LARGE RESIDENTIAL DEVELOPMENT CORRESPONDENCE FORM

RESPONSE TO THIRD PARTY APPEAL LODGED IN RESPECT OF SOUTH DUBLIN COUNTY COUNCIL NOTIFICATION OF DECISION TO GRANT PERMISSION FOR A LARGE-SCALE RESIDENTIAL DEVELOPMENT COMPRISING THE CONSTRUCTION OF 131 RESIDENTIAL UNITS, ACCESS, INFRASTRUCTURE, CAR PARKING, OPEN SPACE BOUNDARY TREATMENTS AND ALL ASSOCIATED SITE DEVELOPMENT WORKS AT NEWCASTLE SOUTH, NEWCASTLE, CO. DUBLIN.

SOUTH DUBLIN CO. CO. REG. REF.: LRD23A/0011 AN BORD PLEANÁLA REF.: ABP-319500-24

Figure 3 - Extract from DBFL Technical note showing access to the appellants lands.

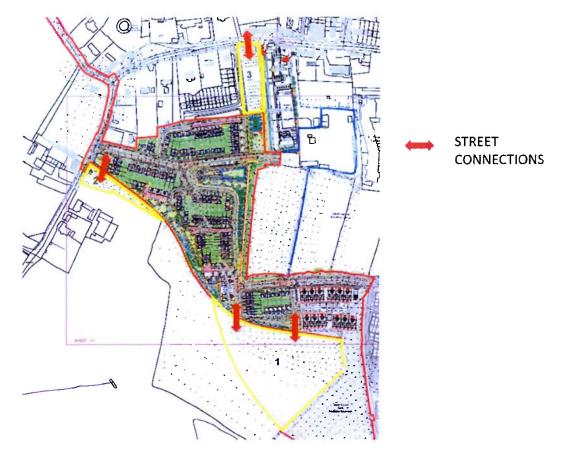
At Section 3 of the third-party appeal, the appellant raises issue primarily with the lack of detail provided in relation to the form of the proposed access arrangements to the appellants lands. The appellant also raises issue with conditions included in the notification of decision to grant permission requiring details of the access roads to be agreed with the Council 'prior to commencement' of development on the site.

We refer to the Technical Note prepared by DBFL Consulting Engineers which accompanies this appeal response and sets out a technical civil engineering response to the matters raised in relation to the provision of services and access to the appellants lands. It is important to highlight that the proposed street layout within the development provides for 3 no. future street connections to the appellants lands at Plot 1 and 2 (refer to Fig. 3 below) providing permeability and connectivity to allow for the future development of these lands. It is also noted that whilst access can be provided to Plot 3 from Main Street to the north and/or from the west, it is also possible to facilitate an access from the subject lands to the south as shown on Fig. 2.2 of the accompanying Technical Note. Cairn confirms that they are not opposed to providing an additional connection to the north as shown and welcome a condition requiring such an amendment to be agreed through compliance procedures with SDCC.

In relation to the boundary treatment along the southern boundary of the site, it is confirmed that Cairn Homes are agreeable to constructing a blockwork wall, capped, and rendered, along the entire boundary if considered appropriate by An Bord Pleanála and a condition to confirm same is welcomed if considered appropriate.

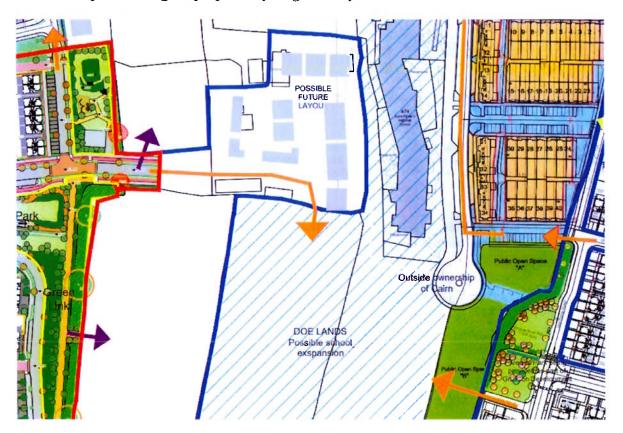
- 20. Layout Plans (no greater than 1:200) to show
- a. connections right up to the site boundary to ensure that no ransom strips are created on the links between the applicants' site and neighbouring developments.
- b. the proposed connections from the subject site to the Graydon development to the East via the DOE lands around St. Finian's School.
- c. segregated footpaths and cycle tracks.
- d. uncontrolled crossings at internal road junctions which could possibly combined with traffic calming ramps.

Although not shown at 1:200 scale a layout plan has been submitted showing connections right up to the boundary of future connections.
